Access Compliance Report

Public Rights-of-Way

(Curb Ramps)

Intersection ID: 51610	Main Street: LUMSDEN_RD	Cross Street: REEFTON_RD	Location: W
ADA ID: D5E986F388F6	Ramp Type: PerpDiag	Initial Pass/Fail: Fail	Overall Compliance: No
Severity Score: 37.5			
Codes/Mitigation Info/Possible Solution		Field Measurements/Component Compliance

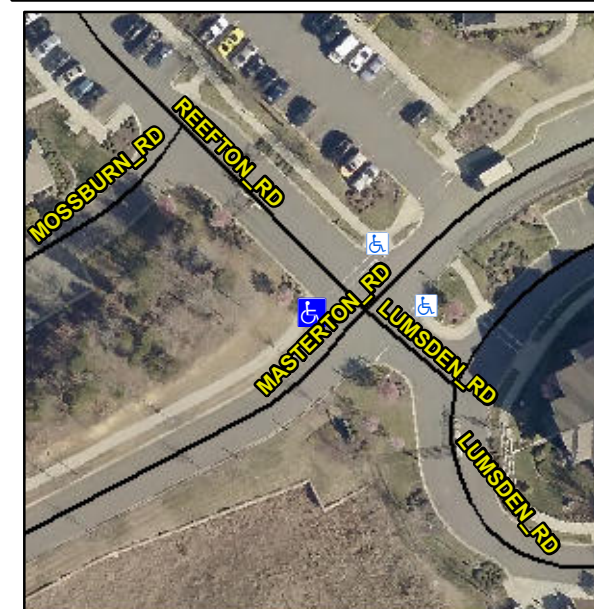
R304.2.2, R304.5.3

Compliance	Description	Data	Compliance	Description	Data
N/A	Ramp Length (in)	107.0	No	Ramp Slope (%)	14.5
Yes	Ramp Width (in)	48.0	No	Ramp XSlope (%)	6.4
N/A	Flare Type LT	N/A	N/A	Flare Type RT	N/A
N/A	Flare Slope LT (%)	N/A	N/A	Flare Slope RT (%)	N/A
N/A	Flare Traversable LT?	N/A	N/A	Flare Traversable RT?	N/A
N/A	Landing Length (in)	N/A	N/A	DWS Provided?	N/A
N/A	Landing Width (in)	N/A	N/A	DWS Contrast?	N/A
N/A	Landing Slope (%)	N/A	N/A	DWS Length (in)	N/A
N/A	Landing X Slope (%)	N/A	N/A	DWS Full Width?	N/A
N/A	Landing Curb? (Y/N)	N/A	N/A	DWS Offset (in)	N/A
N/A	Shared Landing?	N/A			
N/A	Gutter Ponding?	N/A	N/A	Gutter Slope (%)	N/A
N/A	Gutter Lip Ht (in)	N/A	N/A	Gutter X Slope (%)	N/A
N/A	Painted X Walk1?	Yes	N/A	Painted X Walk2?	Yes
	X Walk 1 Direction	To SE		X Walk 2 Direction	To NE
N/A	X Walk 1 Width (in)	48.0	N/A	X Walk 2 Width (in)	45.0
	X Walk 1 Slope (%)	2.6		X Walk 2 Slope (%)	2.7
	X Walk 1 X Slope (%)	3.7		X Walk 2 X Slope (%)	3.7

Remove & Replace Curb Ramp With Two New Directional Ramps or Equivalent.
